**Contract Program or Project Title:**      **Technical Update of Reactor Pressure Vessel Structural Integrity Program  
Materials Science and Technology Division**

**Subject of this Document:**                      **Review of Draft NUREG Report on Technical Basis for Revision of Regulatory Guide 1.99**

**Type of Document:**                              **Letter Report**

**Date of Document:**                              **March 31, 2008**

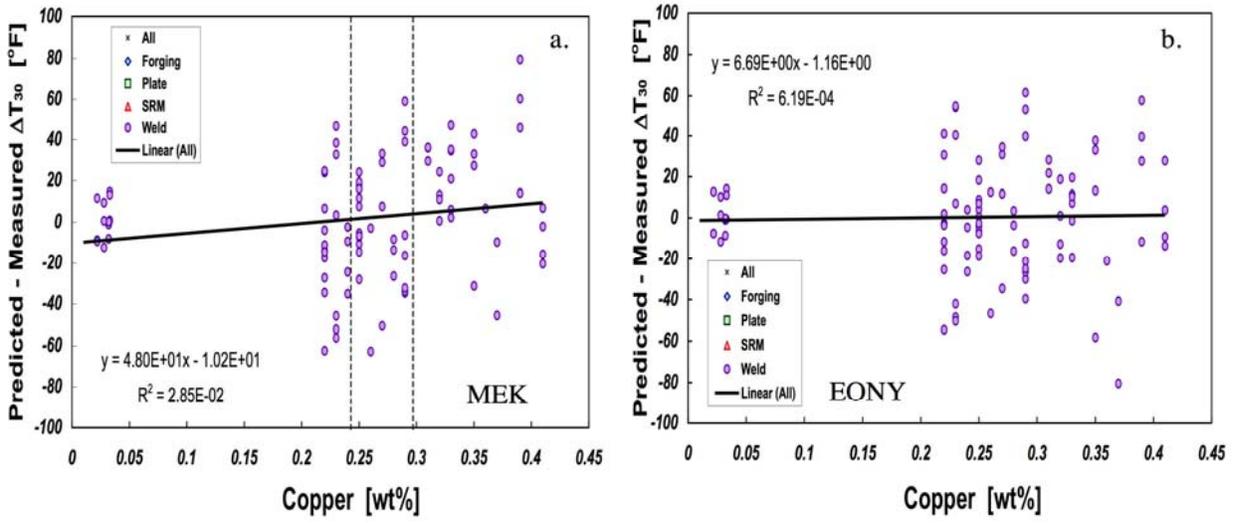
**Fig. 2.19. Residuals for the Linde 80 welds comparing the (a) MEK and (b) EONY models.** The residuals for the EONY model are reasonably well centered about zero, while there is a clear trend toward overprediction of the TTS by the MEK model at higher Cu content that may or may not be statistically significant.

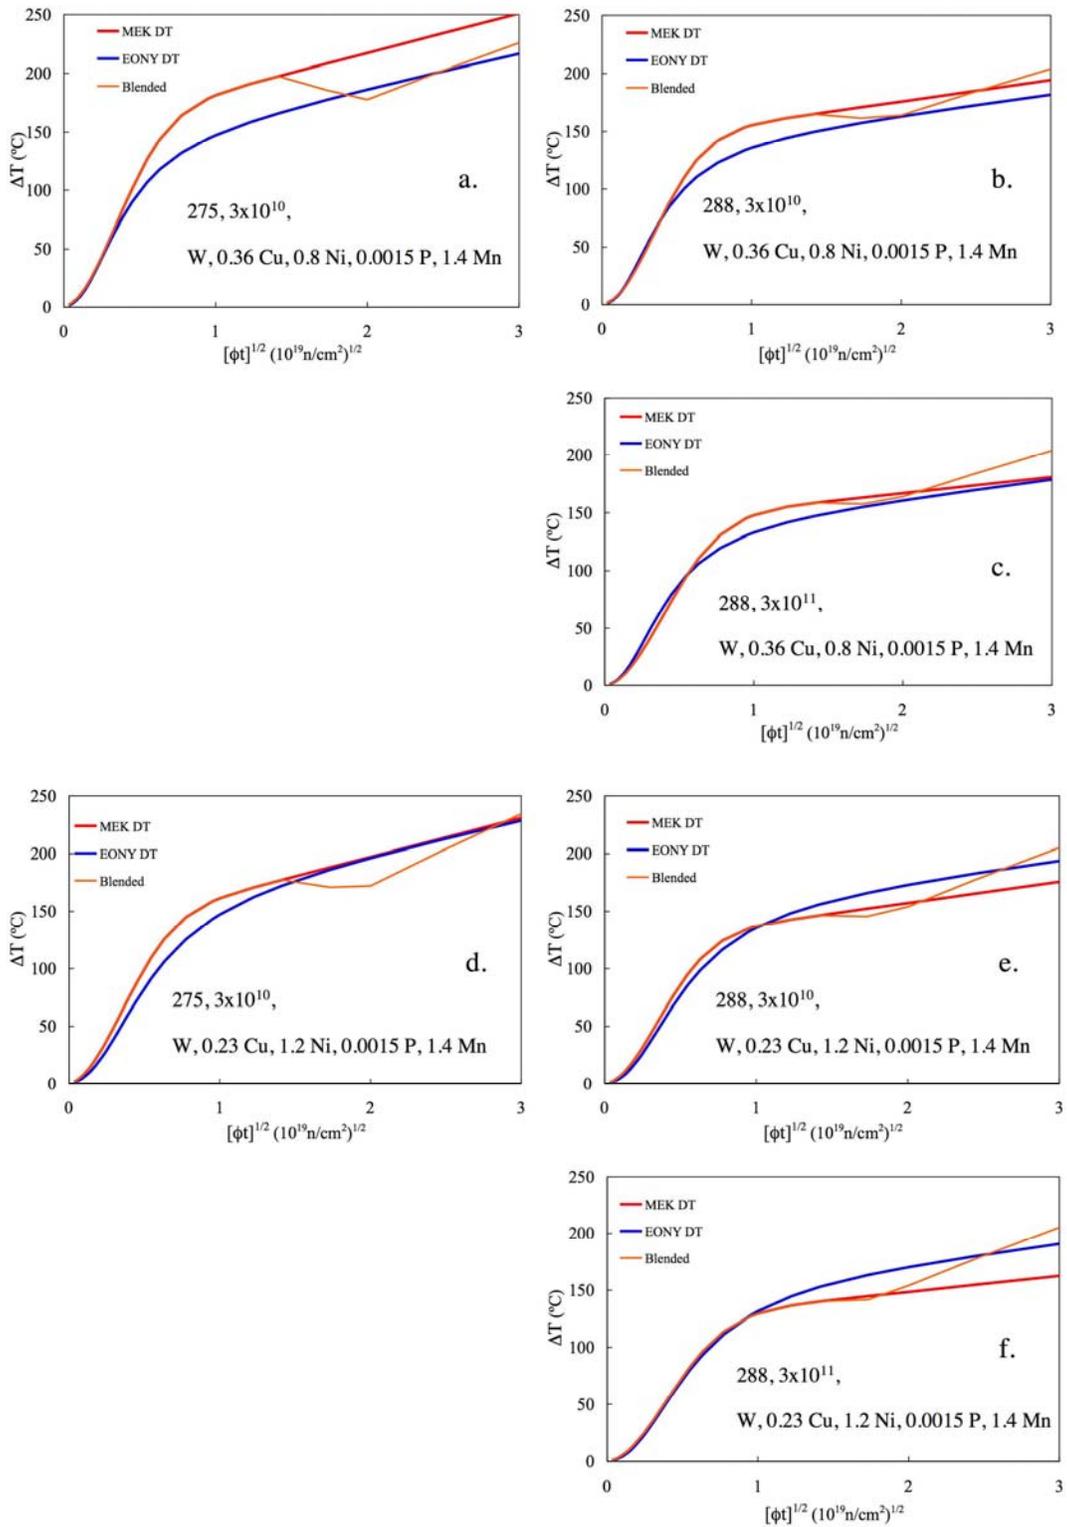
- The RADAMO model does not always work as intended. Indeed, it systematically *underpredicts* the low-flux TTS models in perhaps what are the most important embrittlement regimes associated with high-sensitivity steels irradiated at lower flux and temperature. Underprediction is illustrated in Fig. 3.11, which shows TTSs for the MEK and EONY optimized models for alloys with compositions similar to Maine Yankee (0.36 Cu, 0.8 Ni) and Palisades (0.23 Cu, 1.2 Ni) welds. Moreover, as shown in Fig. 3.11, the blended curves (i.e., RM-9 and RADAMO combined) often exhibit abrupt changes in slope (e.g., from positive to negative) with increasing fluence.

Thus, in summary, we do not find the recommendation in the draft NUREG report related to the use of the RADAMO model to be acceptable for predicting low-flux TTS.

Fig. 5.1. Attenuation of neutron fluence,  $E > 0.1$  MeV and  $E > 1.0$  MeV, dpa, and the exponential formula from RG 1.99-2 for typical PWR and BWR vessels.

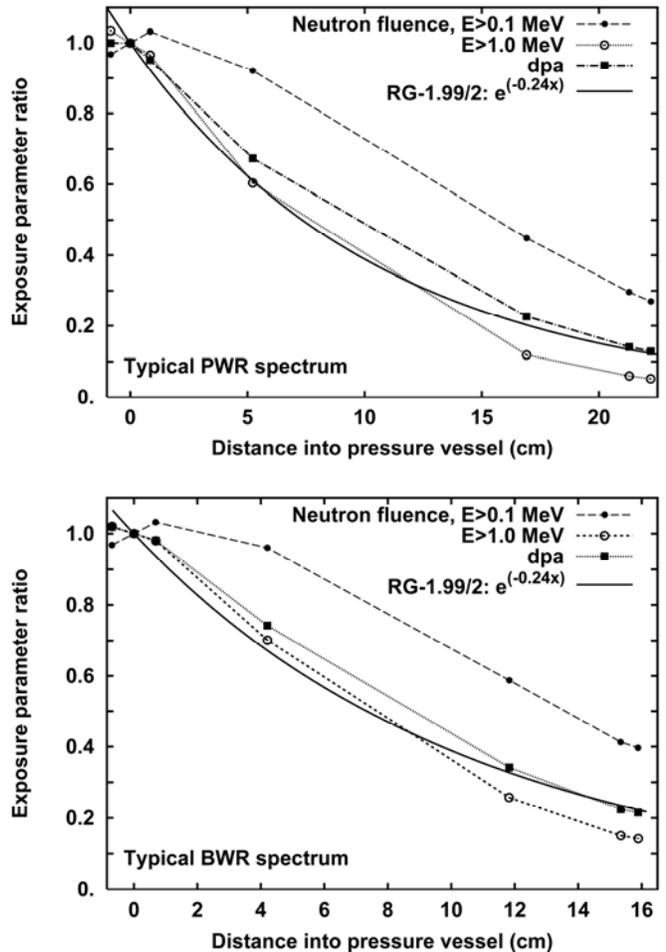
The difference between neutron exposure parameters is illustrated in Fig. 5.1 (Stoller 01), where the fluence with  $E > 1.0$  MeV is compared with the fluence with  $E > 0.1$  MeV, dpa, and the exponential attenuation function currently specified in RG 1.99-2 (RG 1.99-2). Results are shown for typical pressurized water reactor (PWR)

Since the differences between the calculated dpa profiles and the exponential formula shown in Fig. 5.1 are not large, an alternate procedure would be to permit the use of the exponential function in RG 1.99-2 as a substitute for the dpa ratio in the equations shown above. However, this will be slightly nonconservative in some cases, and it is believed that current neutronic practice in the industry already includes calculation of the required dpa values.

In summary, the current Regulatory Guide 1.99-2 procedure recommended in the draft NUREG for attenuation should not be employed. Whichever embrittlement model is used, it is important that it be applied in a self-consistent manner with respect to flux, spectral effects, and irradiation temperature when predicting embrittlement at locations within the RPV wall. The authors of this report recommend the two-step procedure enumerated earlier in this section.

**Fig. 5.2. Impact of six different damage attenuation models on predicted DBTT shifts at the 3/4-T position for EONY and RM9 embrittlement correlations.**

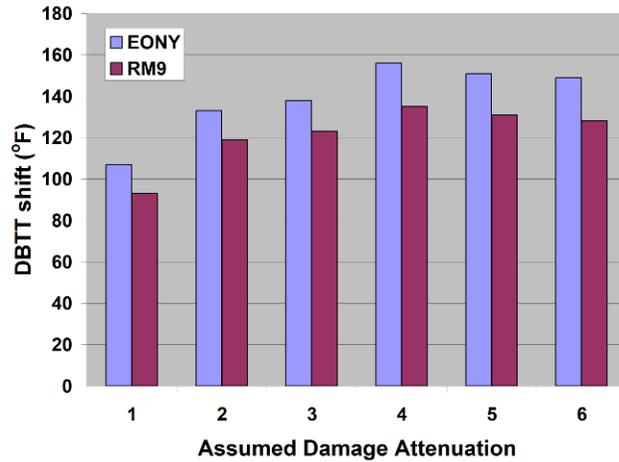
The values listed in Table 5.1 are compared in Fig. 5.2. For the conditions used here, the DBTT shifts predicted by the EONY correlation are higher than those from RM9 for each case, but the relative change is the same from one case to another. Depending on any given reactor vessel's composition and fluence, it is clear that the differences among the various cases may be larger or smaller than those observed in this particular example. However, this example illustrates the
